**UNITED STATES DEPARTMENT OF COMMERCE
Patent and Trademark Office**

09/314,001 05/19/99 ASLANOVA

OFFICE ACTION SUMMARY

DETAILED ACTION

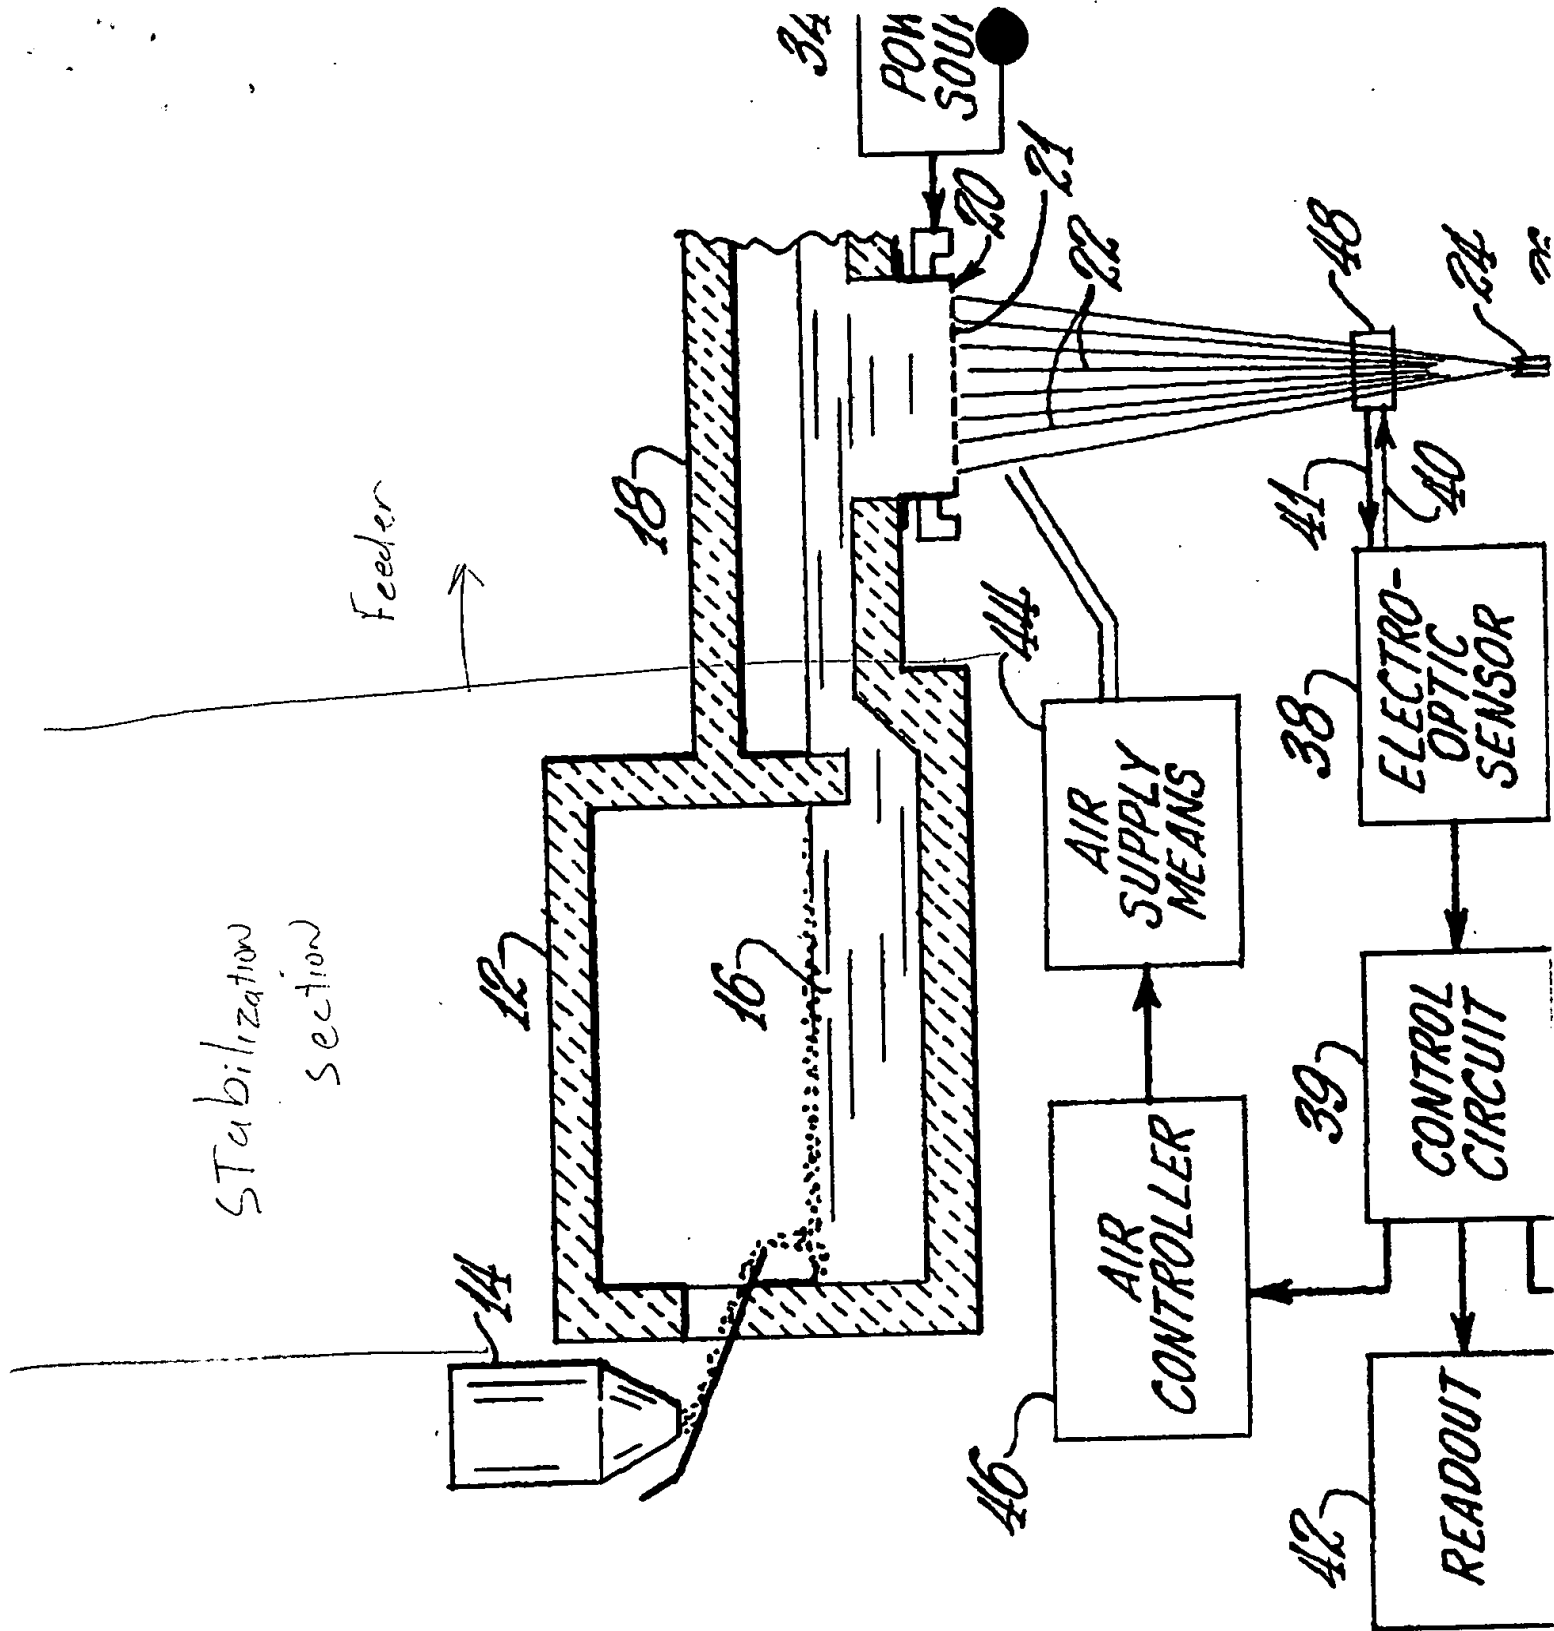
advantages that Shofner discusses. Looking at the attached enlarged Shofner figure. It is clear from the drawing that the glass obtains an even and smooth surface within the stabilization section. It is inherent that the glass temperature and viscosity is stable enough to make the fiber. Thus, the glass is deemed to be stabilized in volume in that it meets Applicant's description at page 4, line 34-26.

As to the second stabilizing: in the Shofner feeder the glass would still be homogenizing - thus it isn't stable - it's still changing. Alternatively, since the glass constituents are flowing it is unstable from a kinetic energy standpoint. They are stabilizing further.

It is argued that invention is allowable because the melt becomes stable in volume because gas bubbles and foam are expelled. The claims do not require this: there is no explicit requirement in the claims; page 5, line 1 and page 4 lines (21-24) states that such is merely "possible"; and it is clear from the drawing that there is no foam in the stabilizing section 16.

It is further argued that the glass is kept in the stabilization section until it reaches the fiber manufacturing temperature. This is an extremely broad limitation - there is no definition for this term. This temperature could be the temperature of the fibers as drawn, the temperature of the flames of attenuation burners, the temperature of the fibers as they are being coated - in fact it could relate to the temperature of some other fiber making process. It is clear that whatever temperature the combination of reference would have, that there is some temperature in a fiber manufacturing process that is equal to it. In fact, since the Shofner temperature is equal to itself,

and since it is glass used in a fiber manufacturing process, it is "a fiber manufacturing temperature."
